Product Change Notification

Bourns® Sensors & Controls Product Line Introduces Model 6639 Product Enhancements

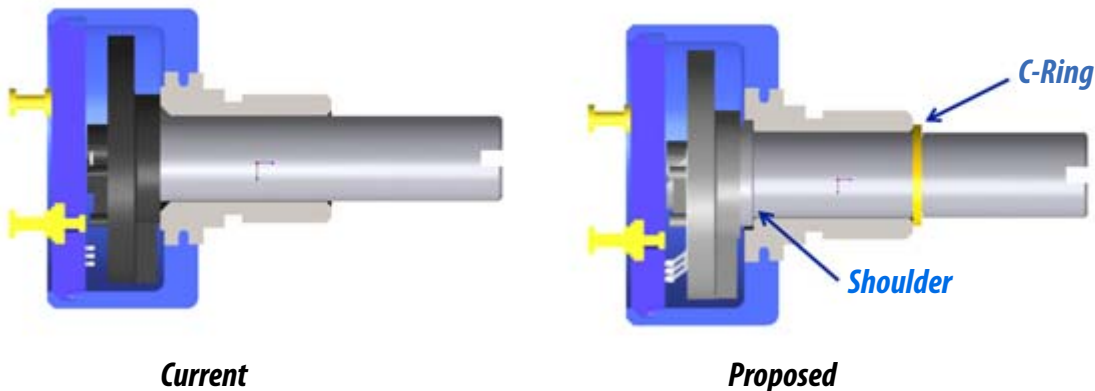
The design enhancements include the addition of a C-ring to help prevent damage that may be induced by excessive axial force applied to the shaft when installing gears or other mechanical devices, and the addition of an internal shoulder to the shaft to better resist shaft pull out from the body if excessive shaft pull force is applied.

Please refer to the shaft/bushing design illustrations below:

Externally, the design enhancements will be recognized by the C-ring that is visible in front of the bushing. The noted enhancements to this product family will have no effect on form, fit or function. All performance specifications listed on the current data sheet will remain unchanged. These design enhancements allow the potentiometer to withstand higher axial loads typically encountered on installation or removal of mechanical devices from the shaft.
